May 31, 2022

California Air Resources Board
1001 I Street
Sacramento, CA 95814

On behalf of our over 500,000 supporters, the Union of Concerned Scientists (UCS) urges the Air Resources Board (ARB) to adopt strong Advanced Clean Cars II (ACCII) standards. The ACCII standards are one the most important air and climate pollution regulations to come before this board and the rules are the culmination of decades of ARB action on clean cars and zero emission vehicles (ZEVs). UCS thanks the members of the board and ARB staff for their work on ACCII and for consideration of concerns UCS and other have raised during the development of the regulations.

Figure 1: A modest increase in the ZEV credit requirement would lead to emissions savings comparable to the 2020 Mobile Source Strategy targets for light duty vehicles.

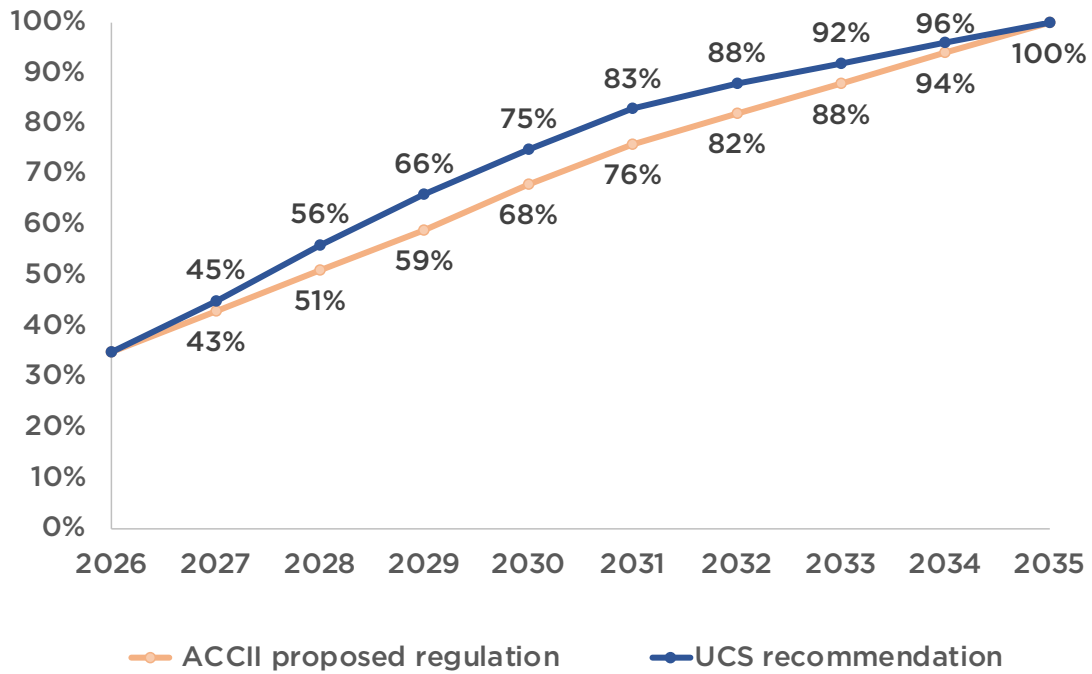
UCS recommends increasing the ZEV credit requirement to require at least 75 percent ZEV credits by model year 2030 (Figure 1). Increasing the ZEV sales requirement would result in an increase of more than 350,000 ZEVs on the road by 2030, based on UCS modeling.⁴ An improved ZEV requirement would also result in nearly 700,000 fewer gasoline vehicles on the road in 2035 (Figures 2 & 3). This modest increase in the sales requirement is estimated to have similar cumulative global warming emissions reductions as the 2020 Mobile Source Strategy for the 2026 to 2035 period and greater reductions for the 2026 to 2045 time period. Therefore, an increase in ZEV requirements is needed to achieve the targets laid out in the Mobile Source Strategy.

Figure 4: ARB's model turnover analysis shows that the proposed ZEV requirement is significantly slower than a "as soon as possible" scenario and is even slower than a "slow phase-in" scenario. (Source: ARB ACCII Initial Statement of Reasons)

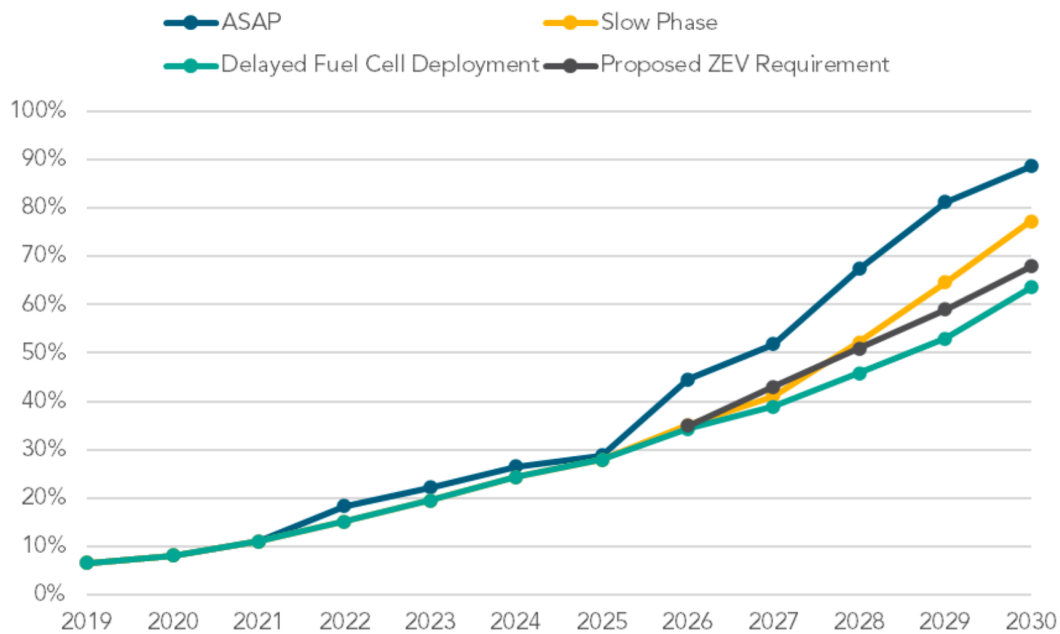
In the Initial Statement of Reasons (ISOR) for the ACCII regulations, ARB staff created scenarios based on approximately 350 vehicle model redesign schedules to predict how industry could shift existing vehicle models to ZEVs. The results of this model show that the proposed ZEV sales requirement is well below the most aggressive deployment scenario (“as soon as possible”) and is below even a “slow phase-in” scenario (Figure 4). The ARB model redesign analysis shows that manufacturers could meet increased stringency targets while remaining on a conventional redesign schedule and not having to prematurely terminate or redesign an existing model.
